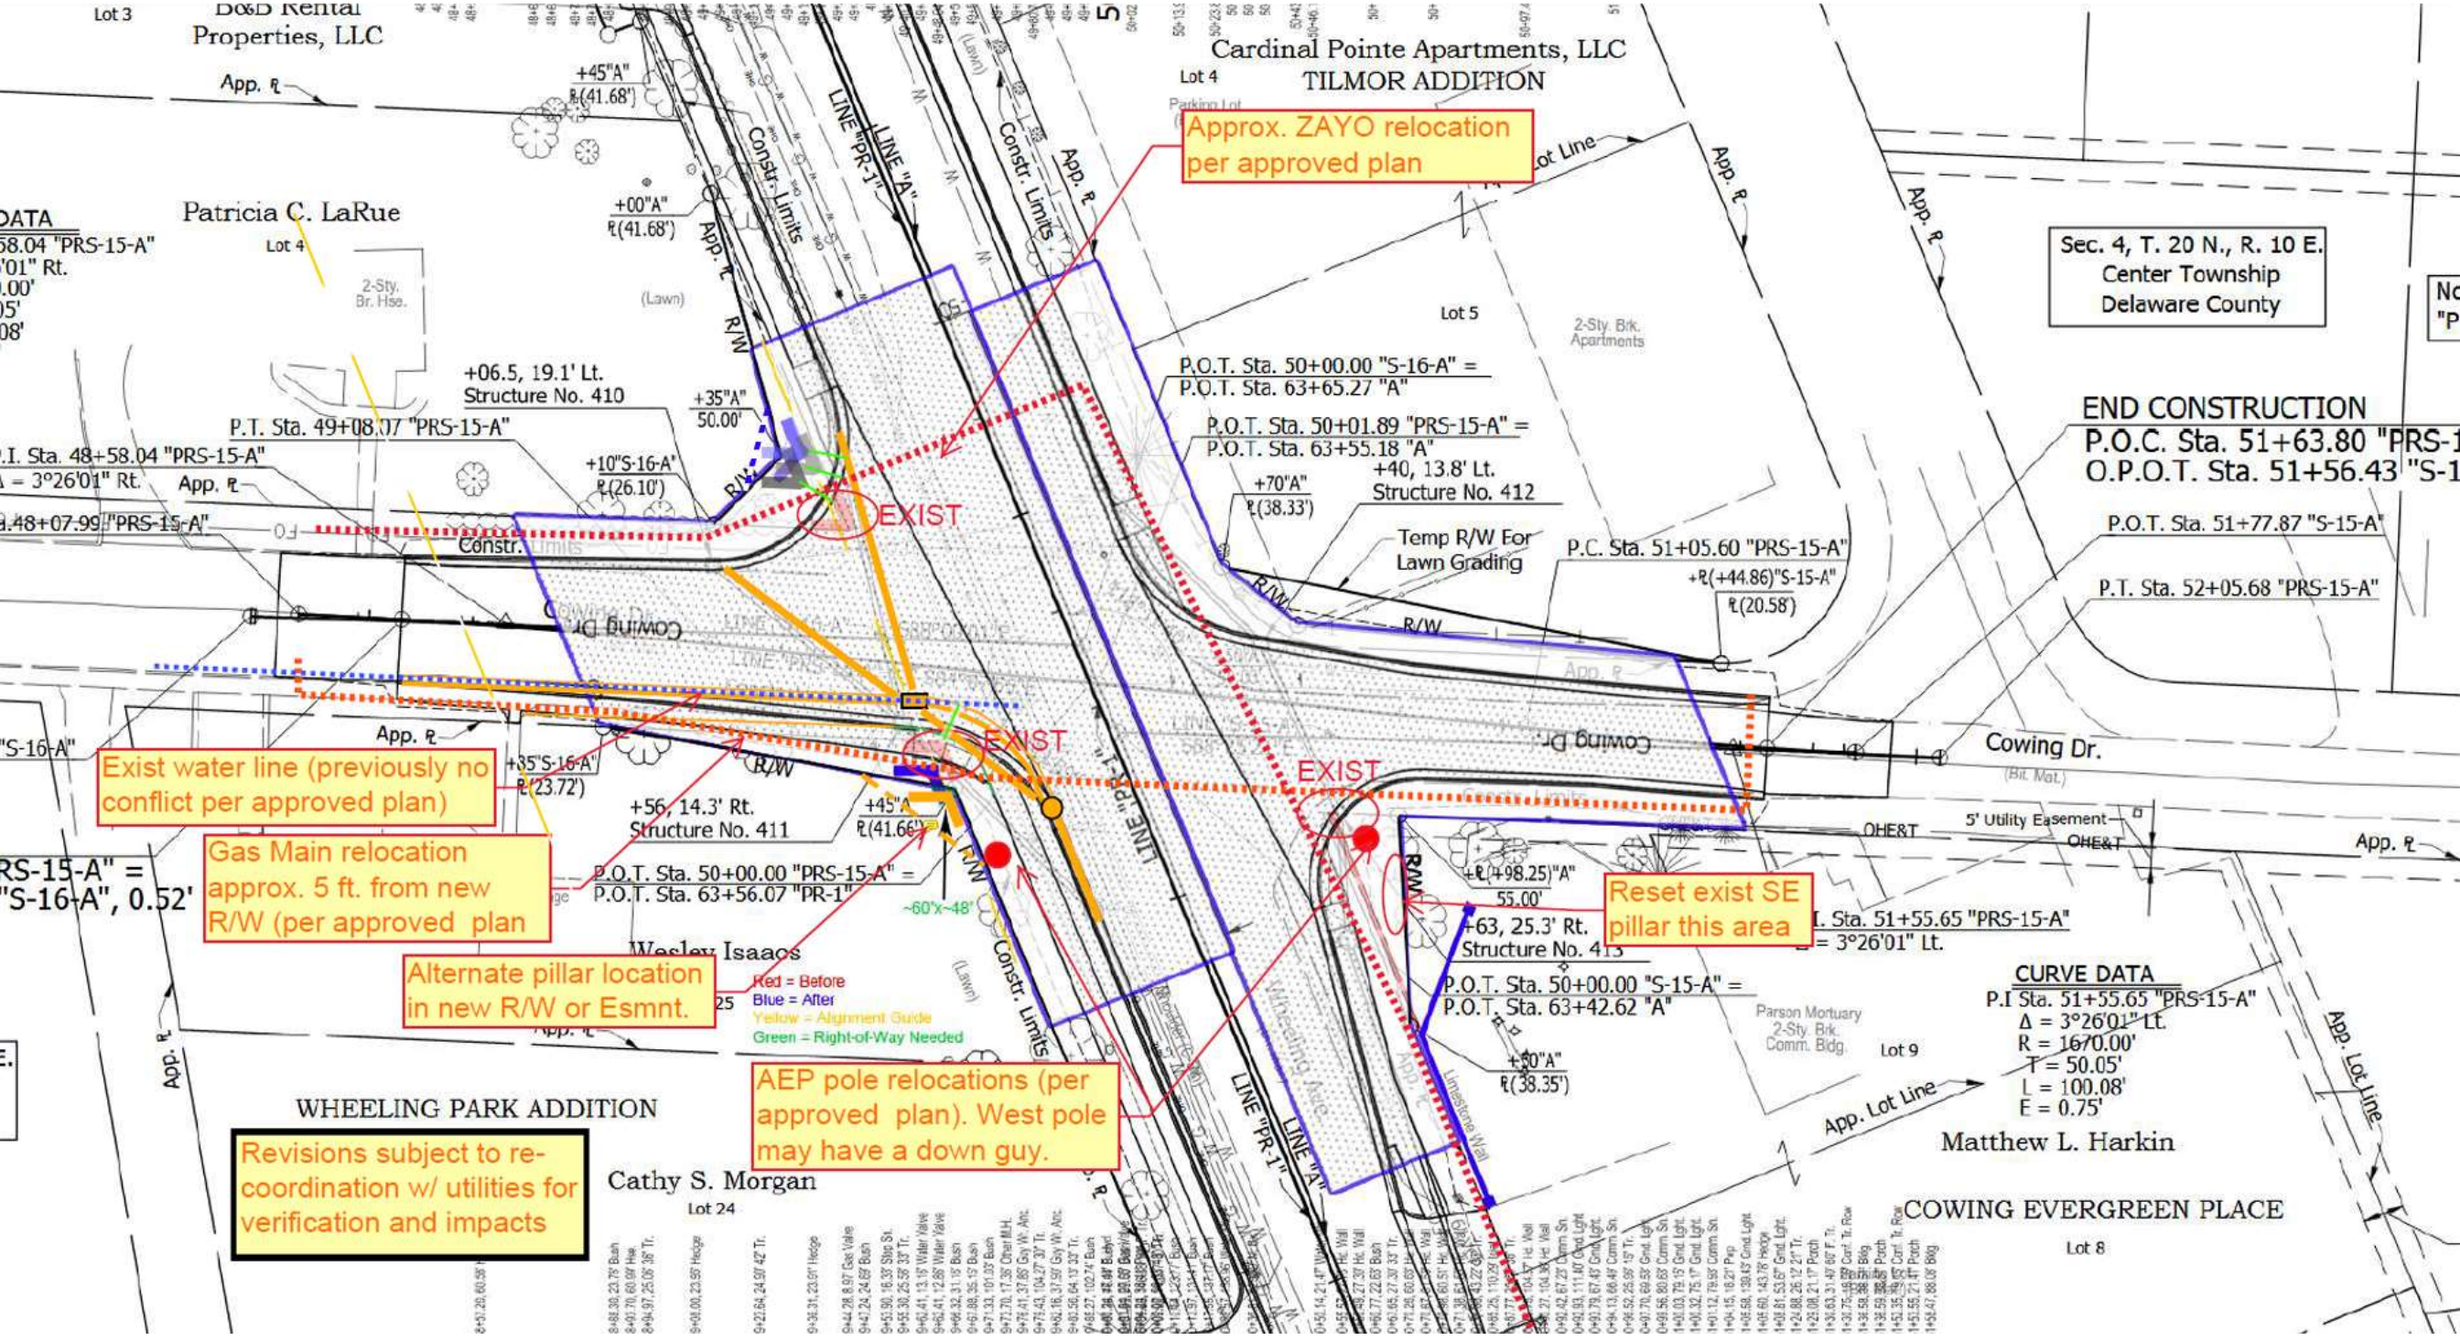
Approx. ZAYO relocation per approved plan
Exist water line (previously no conflict per approved plan)
Gas Main relocation approx. 5 ft. from new R/W (per approved plan
Alternate pillar location in new R/W or Esmnt.
AEP pole relocations (per approved plan). West pole may have a down guy.
Revisions subject to re-coordination w/ utilities for verification and impacts
Reset exist SE pillar this area
Red = Before
Blue = After
Yellow = Alignment Guide
Green = Right-of-Way Needed
Sec. 4, T. 20 N., R. 10 E.
Center Township
Delaware County
END CONSTRUCTION
P.O.C. Sta. 51+63.80 "PRS-1
O.P.O.T. Sta. 51+56.43 "S-1
P.O.T. Sta. 51+77.87 "S-15-A"
P.T. Sta. 52+05.68 "PRS-15-A"
P.C. Sta. 51+05.60 "PRS-15-A"
P.O.T. Sta. 50+00.00 "S-16-A" =
P.O.T. Sta. 63+65.27 "A"
P.O.T. Sta. 50+01.89 "PRS-15-A" =
P.O.T. Sta. 63+55.18 "A"
P.O.T. Sta. 50+00.00 "PRS-15-A" =
P.O.T. Sta. 63+56.07 "PR-1"
P.O.T. Sta. 50+00.00 "S-15-A" =
P.O.T. Sta. 63+42.62 "A"
